# SD57

# STATUS 3D CRYO

07/10/2024

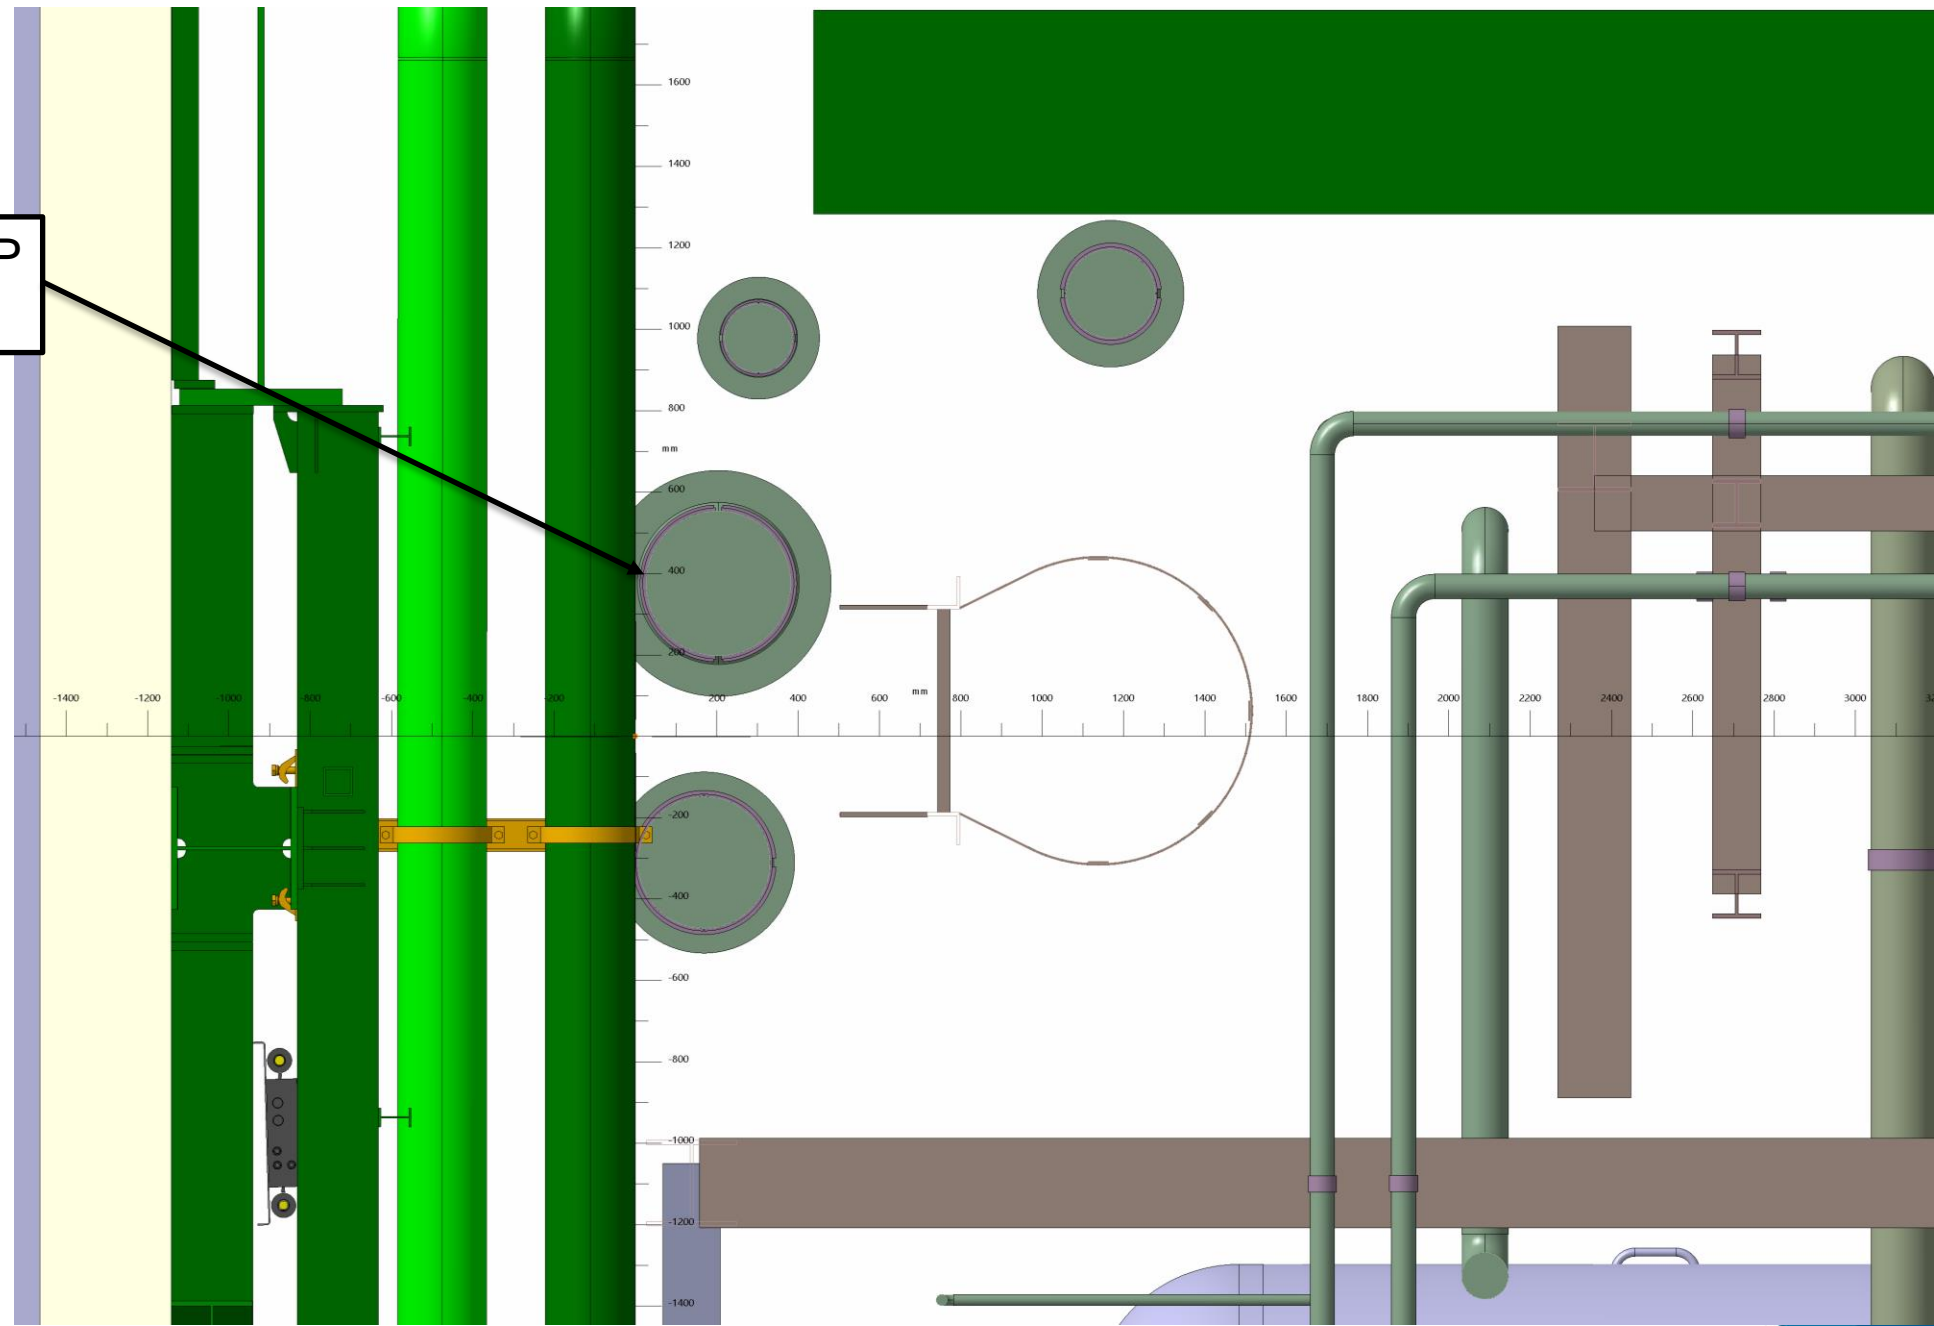
TUYAUTERIES TROP PROCHE

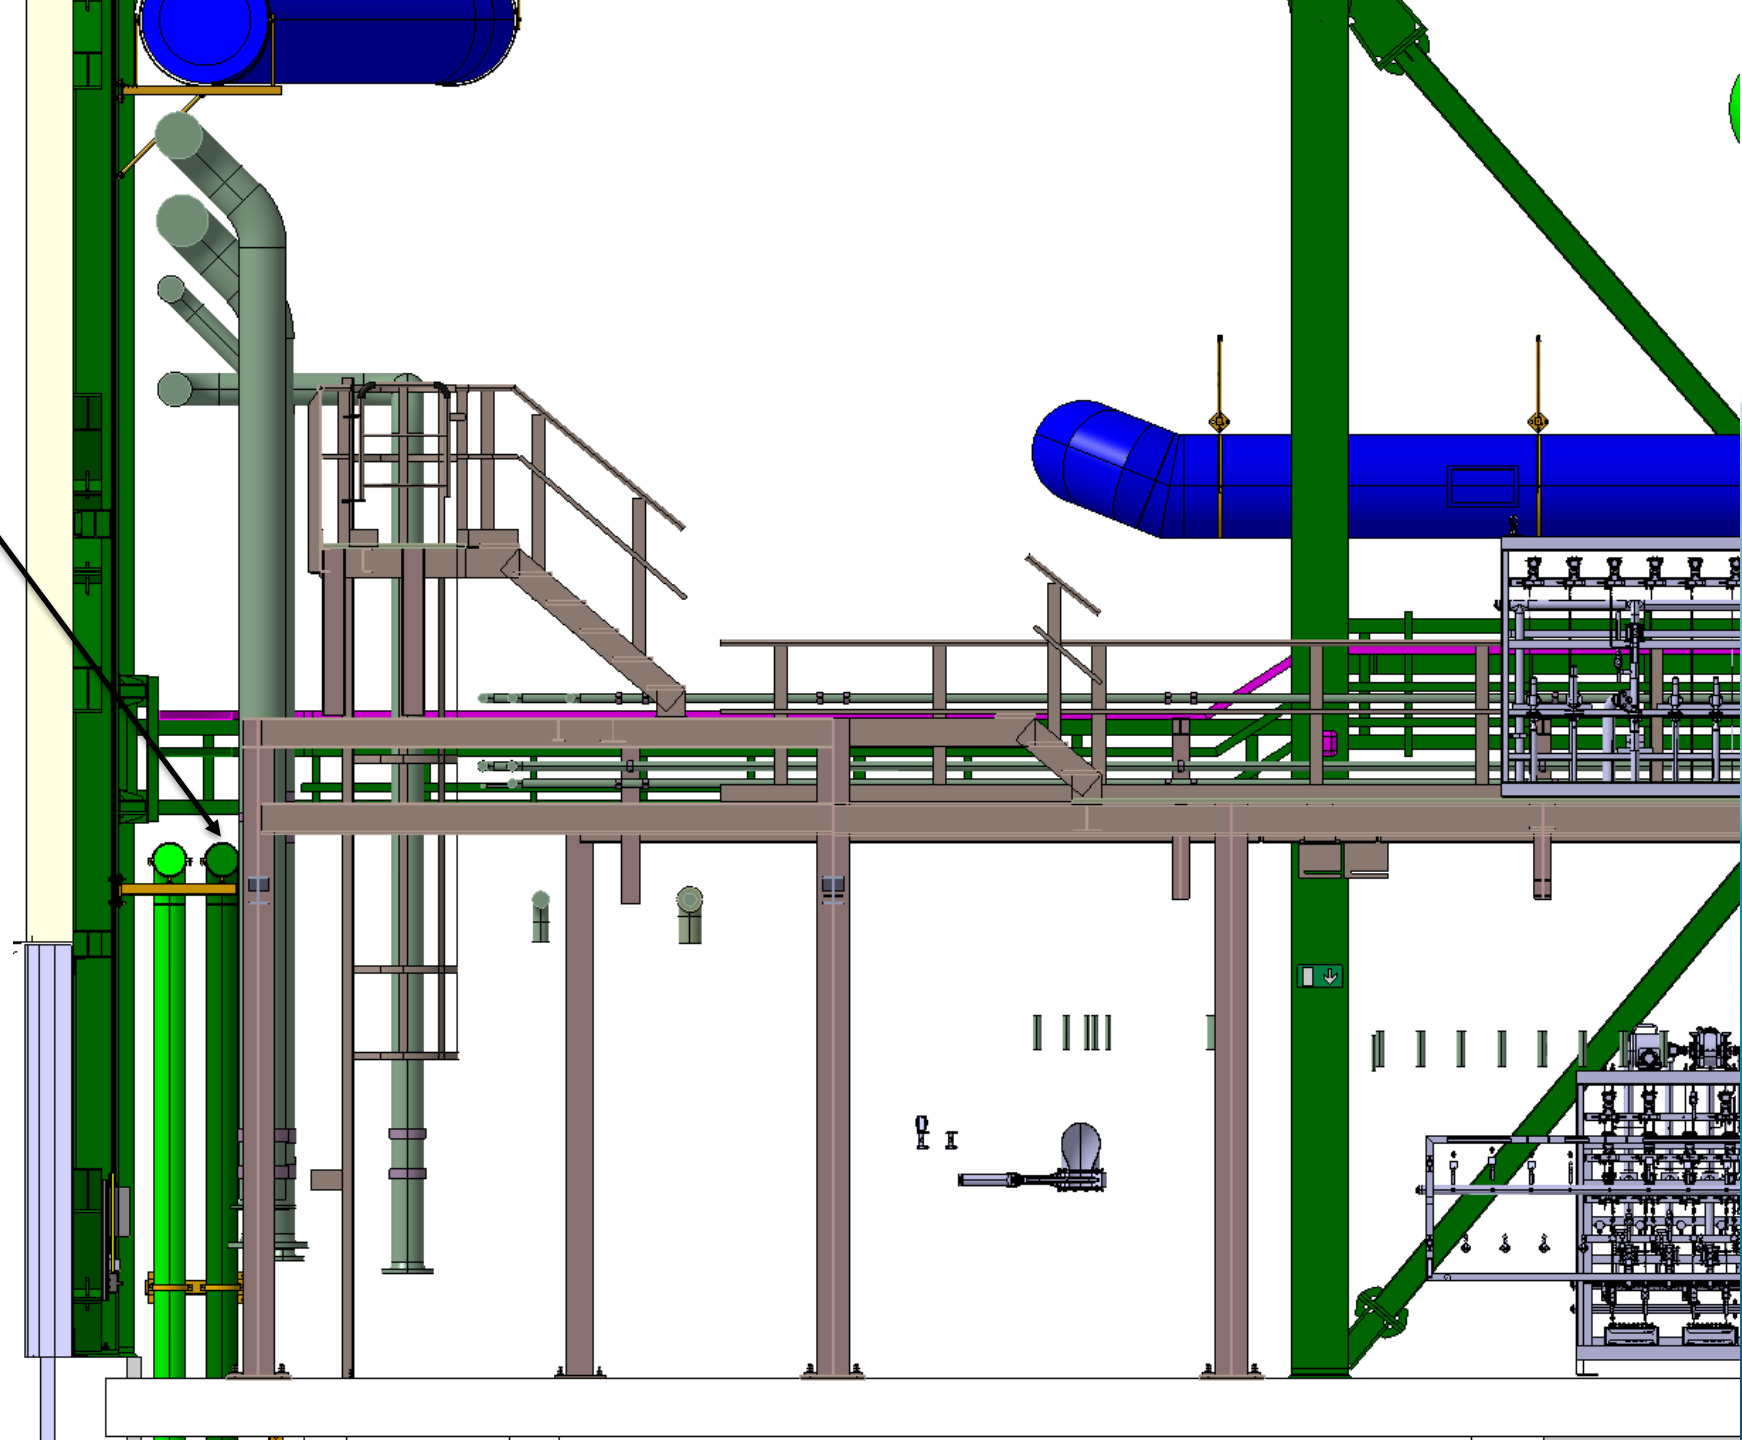
TUYAUTERIES TROP PROCHE
